Sarawia Street Level Crossing Closure: High Level Independent Expert Options Review for the Auckland Transport Board

High Level Options Review for Auckland Transport Board

Client: Auckland Transport

23-Oct-2014

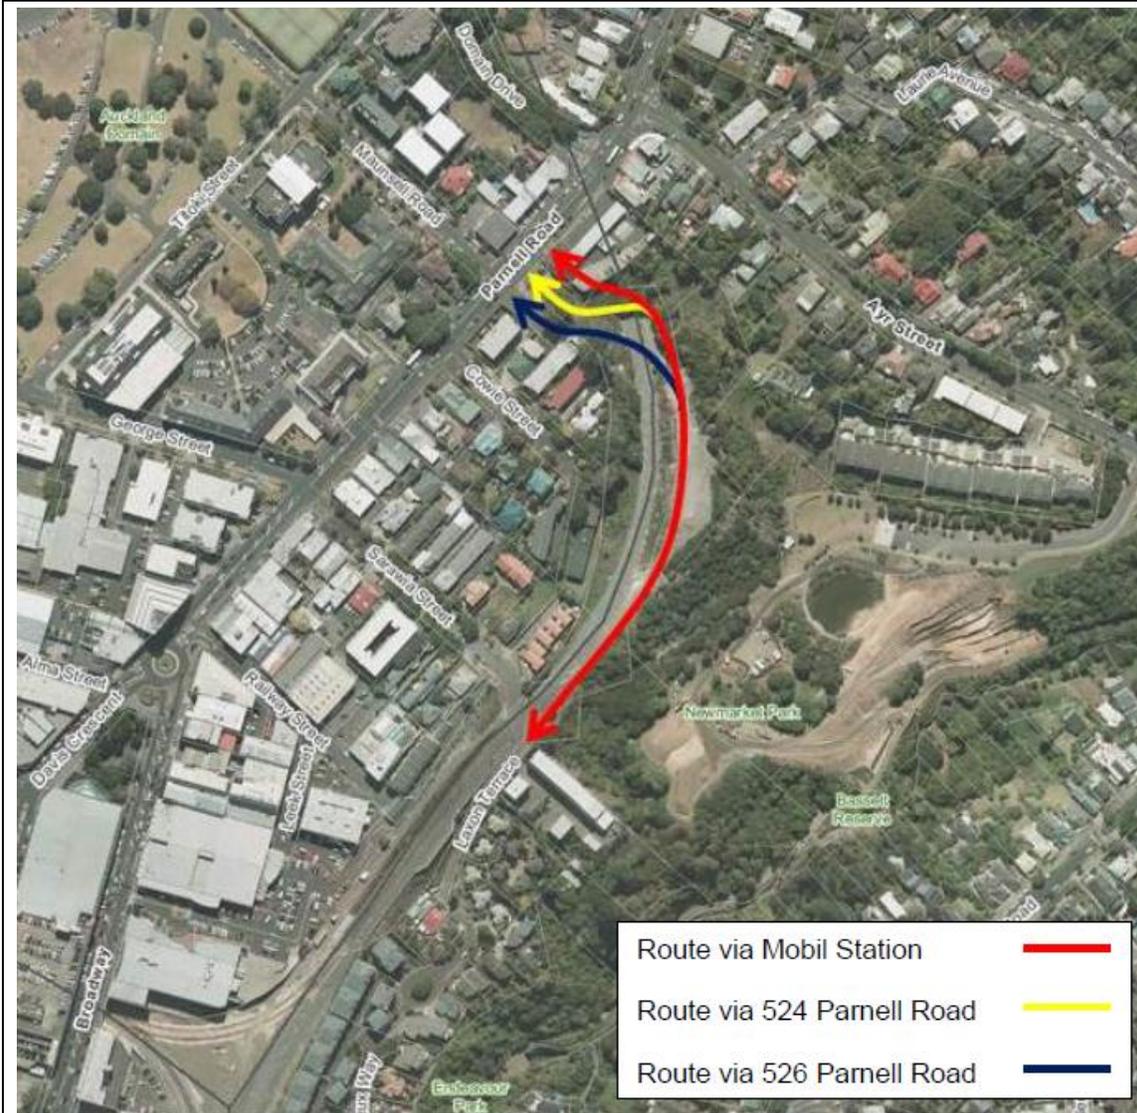
No.	Advantages	Disadvantages
Option 3a: Cowie Street to Through Newmarket Park to Ayr Street		
	BCR of 3.0 Physical Works Cost is \$4.4M	Security concern: Connecting thoroughfare through Newmarket Park to Ayr Street may provide for criminal activity. Currently the access on Ayr Street is gated and locked at night to prevent loitering, however, if this Option is used this gate will need to remain open at all times.
	The through road option was considered more viable than the around road option due to less area of road being located over unstable land, no requirement for land acquisition and a possibility to tie-in with an existing access point on Ayr Street rather than creating another access intersection in an already congested area.	A range of geotechnical issues largely connected to the historic use of Newmarket Park as a landfill site which creates geotechnical and engineering challenges.

Residents, Auckland Council (AC) Parks and Local Board feedback have been negative with regard to this option.
		Newmarket Park is managed on behalf of Auckland Council by Parks, Sport and Recreation Department would be required to provide approval for any proposed works. In addition the Local Board has delegated authority as landowner of parks and reserves.
		A portion of the Newmarket Park within the footprint of the works is a closed landfill and is managed by AC Land and Coastal Remediation Group, which would be required to provide approval for any proposed works.
		Extensive earthworks for rehabilitation, stability and re-vegetation has been undertaken and further works is likely to be unfavourable by local residents and potentially challenging for some AC departments
		There will be a number of RMA and approvals required relating to vegetation clearance and earthworks that are not consistent with the existing zoning and therefore gaining the necessary approvals are likely to be complex.
